ADDENDUM REVIEW OF CONTACT AND NON-CONTACT WATER MANAGEMENT SYSTEMS

COBBLE HILL HOLDINGS

DRAFT FOR MOE REVIEW

20 FEBRUARY 2017

Figure 1: Detail of PEA Cell Toe Construction

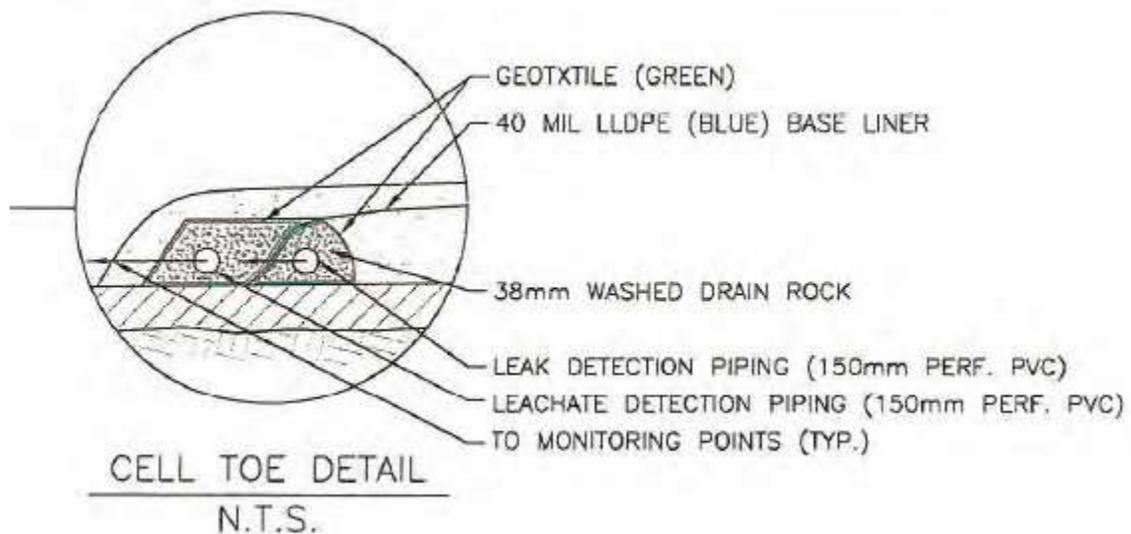
Original designs included a layer of crushed rock over the bed rock to form a “seepage blanket” to level the underlying bedrock. However, the as-built reports did not indicate that crushed was placed over the bedrock but that between 1-3 m of clay was placed over the bedrock.

- PEA design is effective and appropriate for storing contaminated soils that do not contain incompatible chemicals for the lifespan of the LLDPE liner.
- Leachates generated from within the PEA are captured by the leachate collection system
- The leak detection system design should be effective for detecting leaks
- Monday to Friday inspections of the leachate and leak detection pipe inspection ports and reservoirs ensure that any blockages are cleared relatively quickly
- Daily inspection reports on the leak detection and leachate reservoirs allow the operators to monitor the volume of leachate that is collected in the PEA before pumping to the contact water pond.

- Complete the cells that are finished by placing the 0.6 m of protective soil over the cap liner. Surface slope of the PEA should be minimized to avoid erosion of the protective soil cover. Hydroseed steeper areas of the PEA surface if necessary.

Figure 3: Flow Diagram of the Stormtec Water Treatment Plant

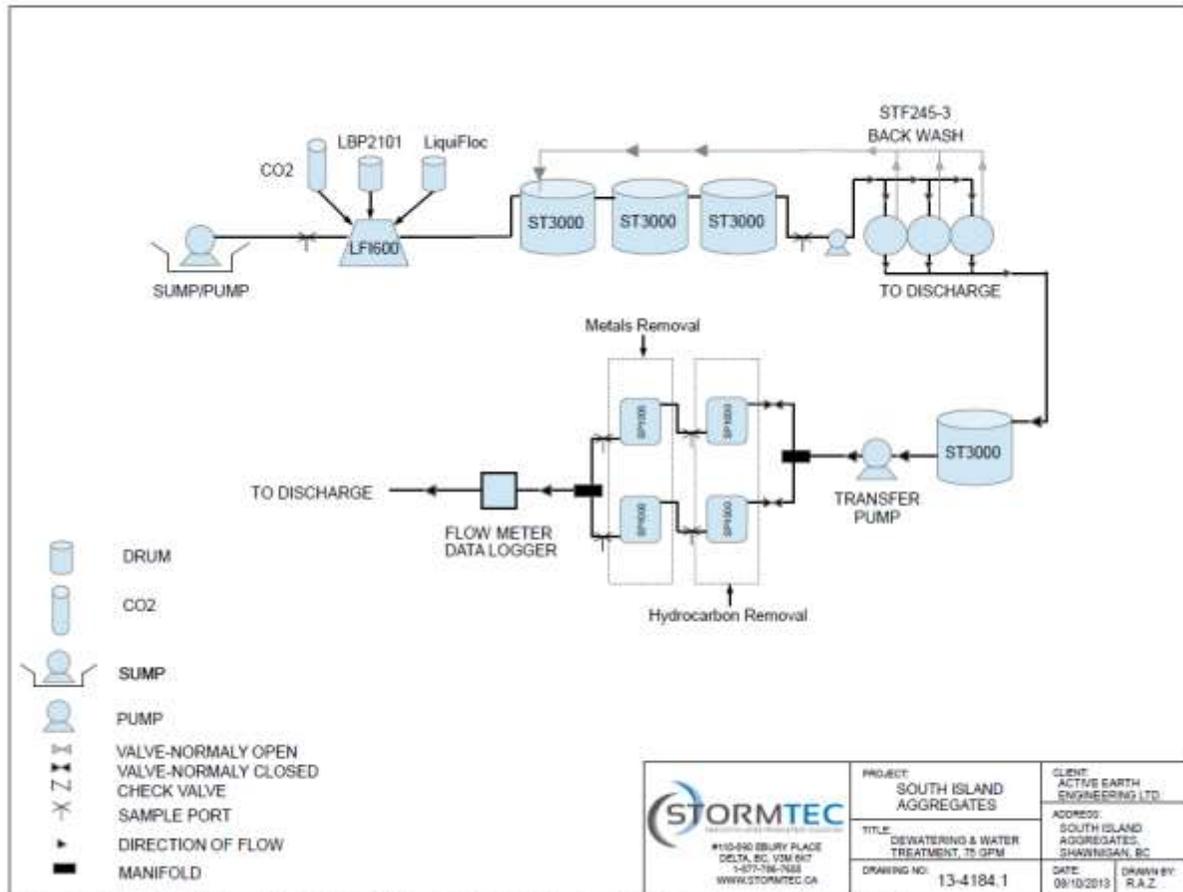
- The contact water treatment system uses standard treatment technology
- The capacity is adequate to handle a 200 year 24 h event with snow melt (see section 2.4)

Figure 4: CWTS Discharge - Nutrients

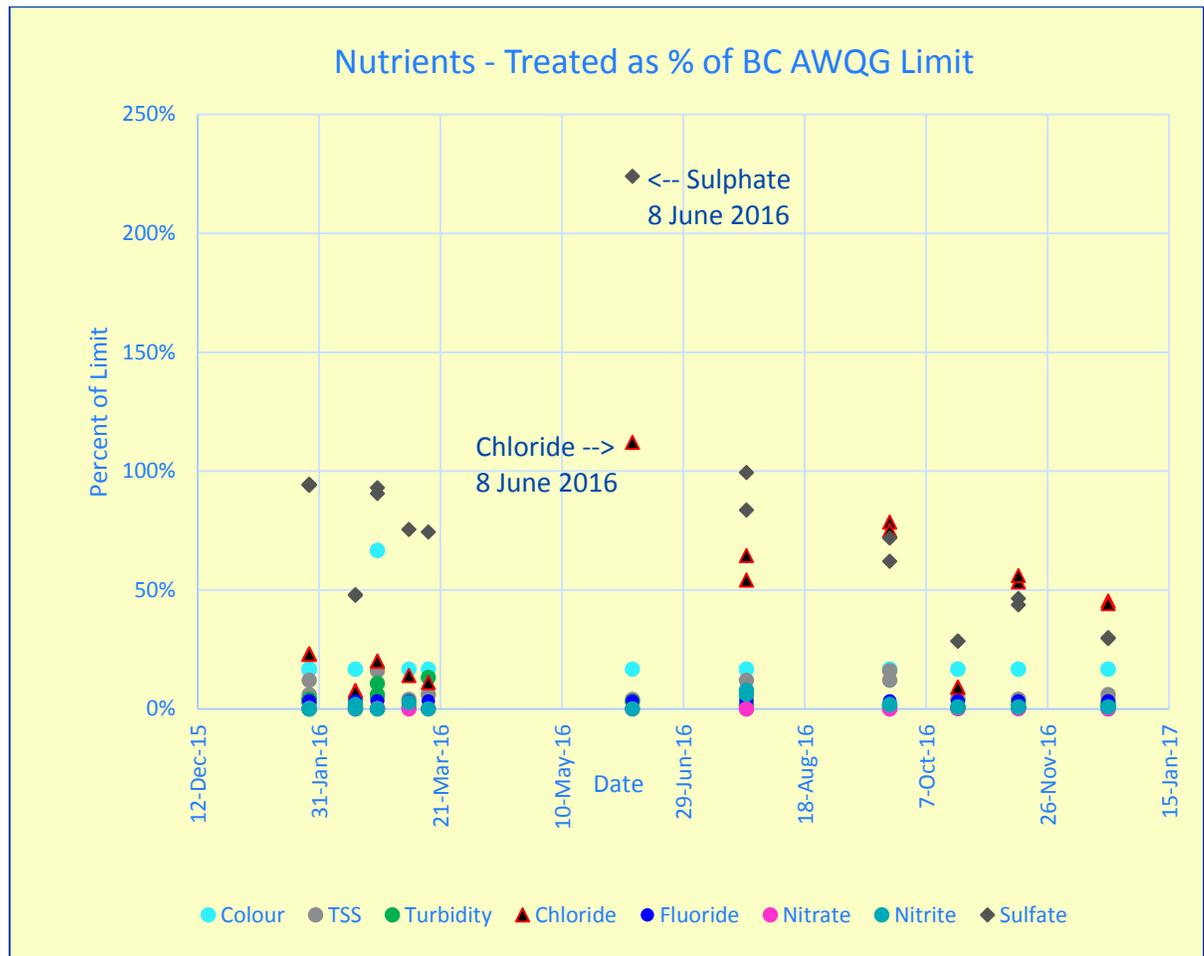
The elevated levels of Sulphate and Chloride in the treated water were not detected at SW-1 after mixing the comparatively small volume of treated water to the much larger volume of non-contact water in the settling pond (see Figure 9).

- Ideally the detection limits for analysis should be no more than half the criteria limits. Better detection limits should be sought for Toluene and Acridine,
- An additional treatment module should be added to remove chloride and sulphate. Many different methods could be used to remove these two ions including ion exchange resin, precipitation with pH adjustment, flocculating agents, RO, nano-filtration, and bio absorption. A quick review with water treatment system suppliers should be conducted to select a cost effective and robust system to handle the range in water quality that will need to be treated. Ideally this could be added in line with the existing water treatment system.

Figure 10: Discharge Point (SW-1) - Metals

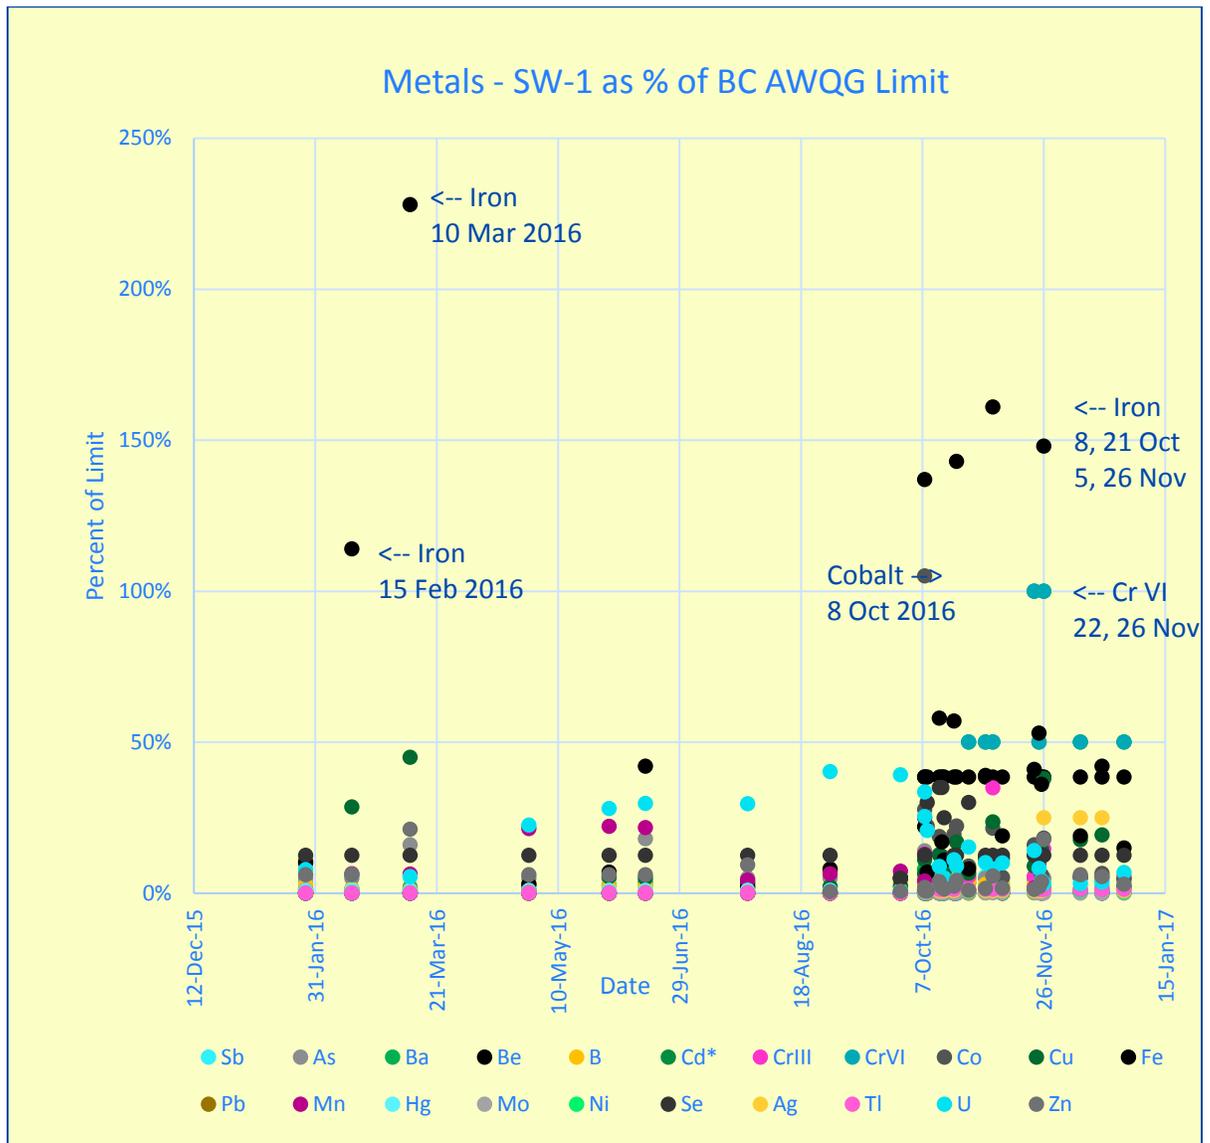
The elevated levels of total Iron (Fe), Cobalt (Co), Chromium VI(CrVI) shown in Figure 10 above were not associated with a spike in total iron or the treated water discharge. Thus the source of these metals is likely from suspended mine solids.

Figure 11: Discharge Point (SW-1) - Dissolved Metals

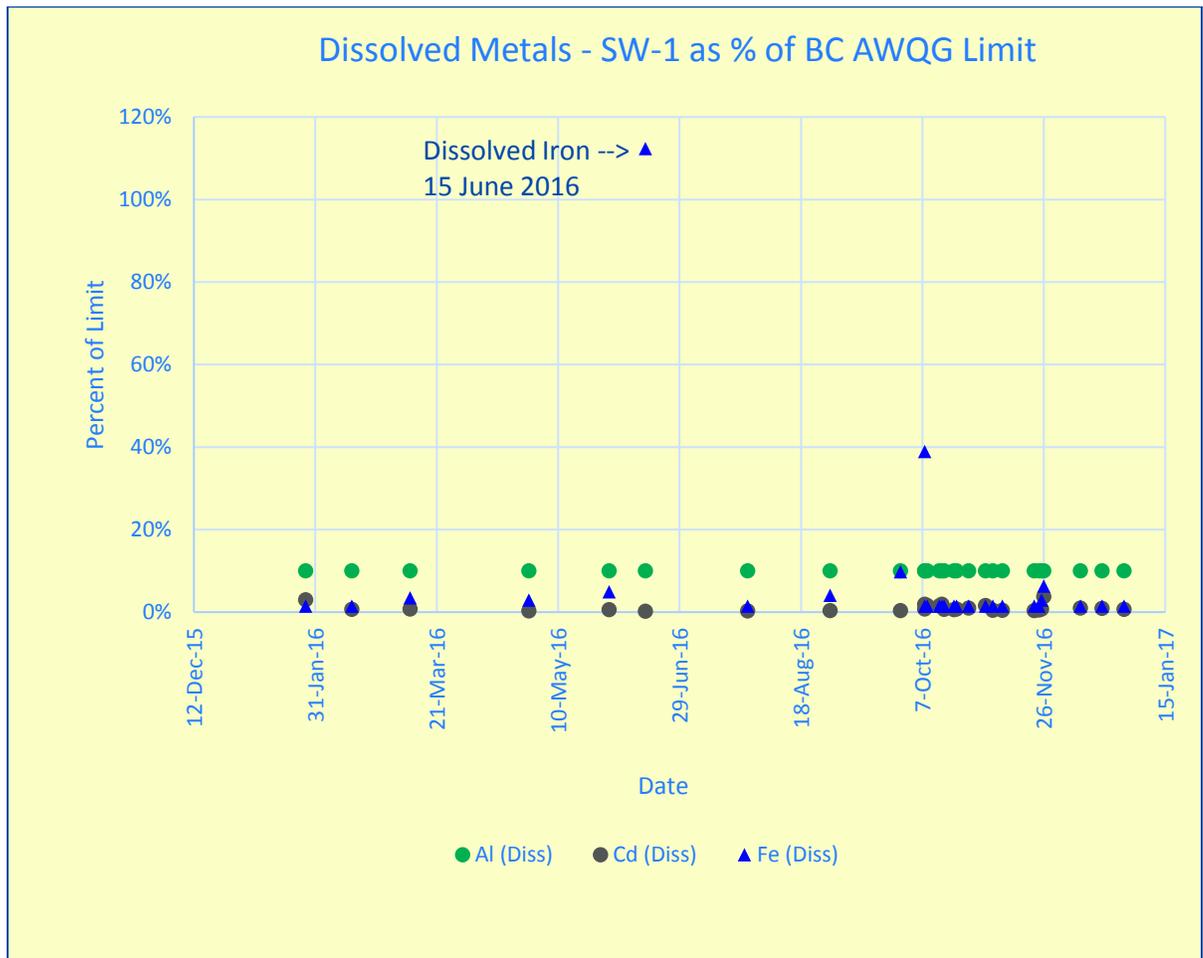
The elevated level of dissolved iron shown in Figure 11 above was not associated with a spike in total iron or the treated water discharge. Thus the source of the iron is likely from background levels in the mine.

Figure 13: Discharge Point (SW-1) - Hydrocarbons, PAHs, Glycols

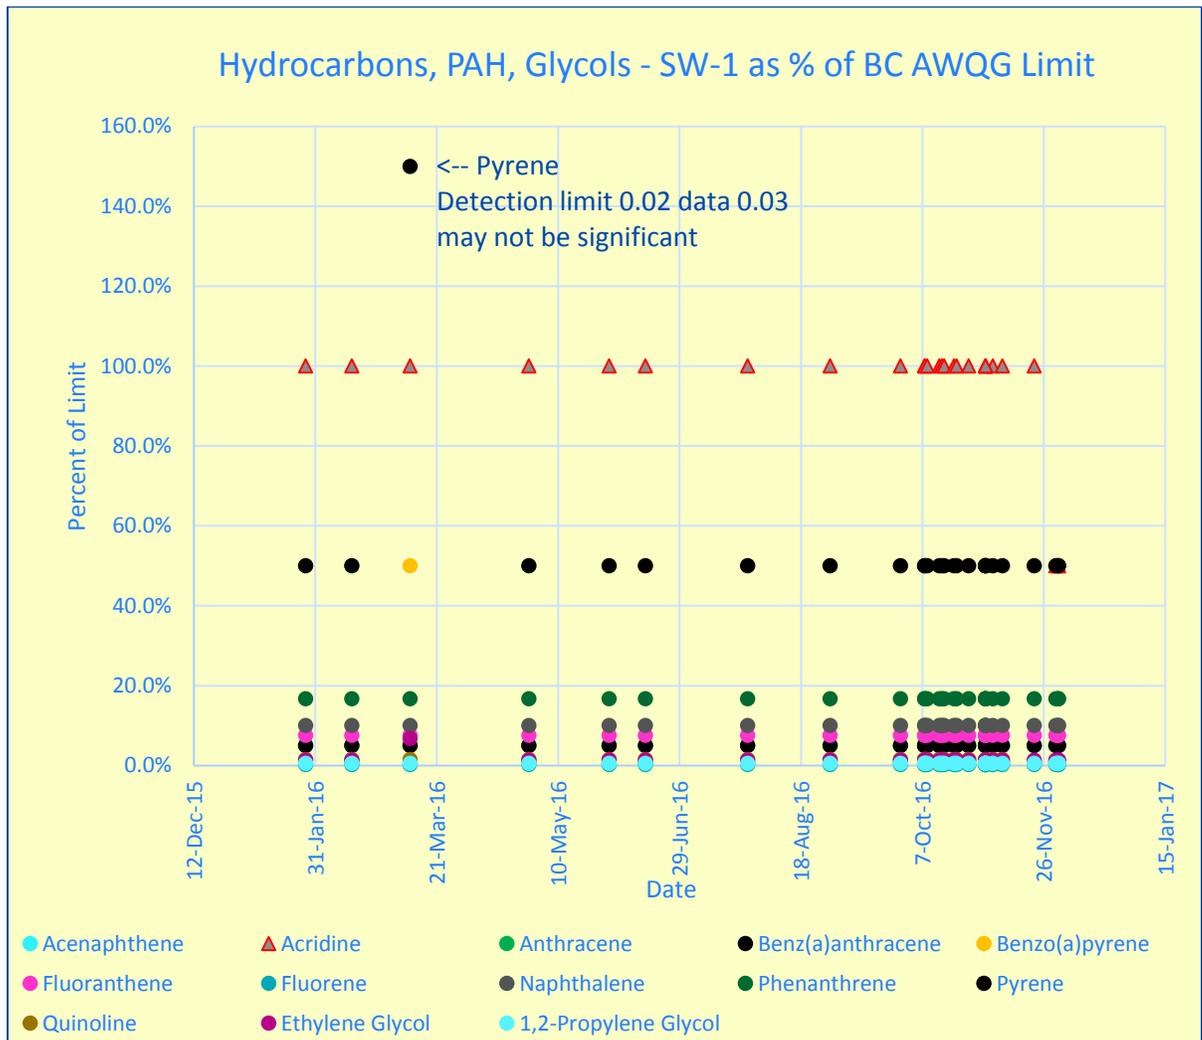
The single pyrene value above the BC AWQG shown in Figure 13 is associated with an HEPH of 1660 mg/L. None of the treated water samples in 2016 exceeded 1000 mg/L. Thus this result was likely from non-contact water.

Figure 14: Percent of Metals in Particulates

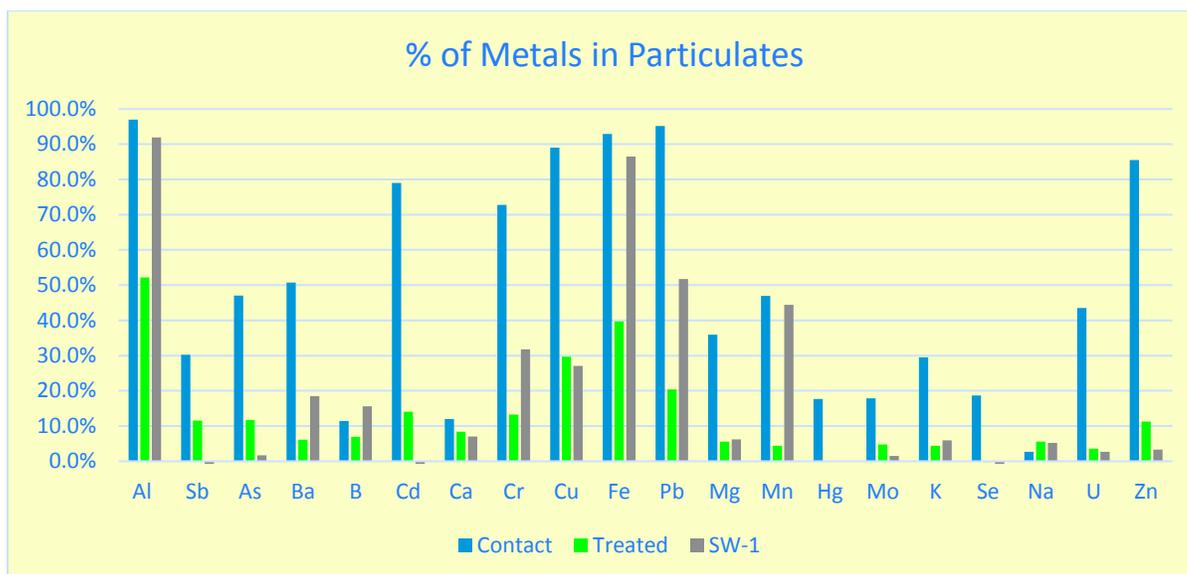
Figure 14 shows that the treatment system is effectively reducing the non-soluble metals (particulates). For example over 85% of the Aluminum (Al), Copper (Cu), Iron (Fe), Lead (Pb), Zinc (Zn) in the contact water is associated with non-soluble metals. After the treatment system: 50% of the Al is non-soluble, 30% of the Cu, 40% of the Fe, 20% of the Pb, and 10% of the Zn. The fact that the non-soluble components of these metals rose up over 85% for the Al and Fe in the SW-1 indicates that they are either coming out of solution to form precipitates or there is Al and Fe particulate loading from the mine water.

Figure 15: Particle Size Distribution

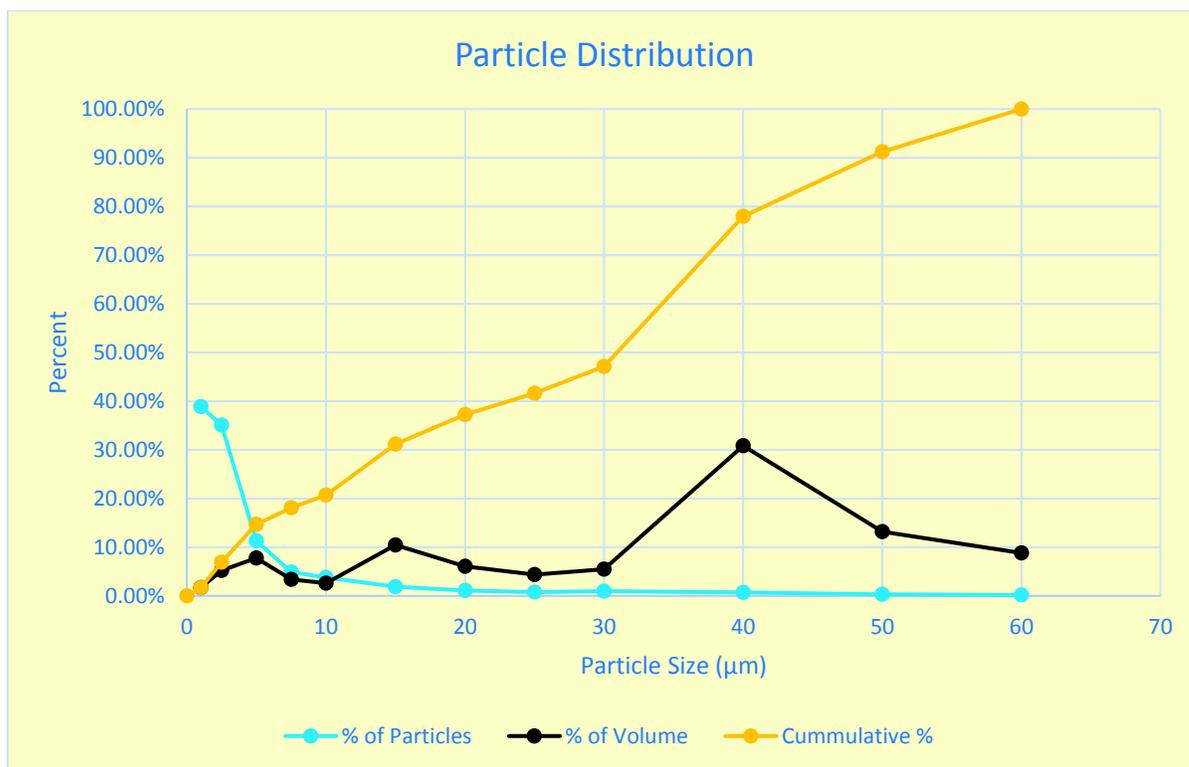
There is a rise in the proportion of metal particulates (Al, Ba, B, Cr, Fe, Pb, Mn) in SW-1, is likely due to the natural metal levels in the mine. Thus if the settling pond is of sufficient size most of the particulate mass should be removed (assuming that metals are uniformly distributed in particles) and thus the site should be able to meet the discharge standards for metals (based on the 2016 data). The elevated metals readings appear to be associated with TSS values of 15 mg/L or more in non-contact water (see analysis for iron exceedances in 2016 in Table 1 below).

Note: Based on the particle distribution graph, 80% of the particle volume is over 10 µm (the target size for settling pond design).

- The settling pond should be increased in size to achieve settling of 10 µm particles (see section 2.3)
- Modify the discharge piping arrangement so the inlet for the discharge is below the pond surface. This will avoid discharge of any oil products that float on the pond surface.
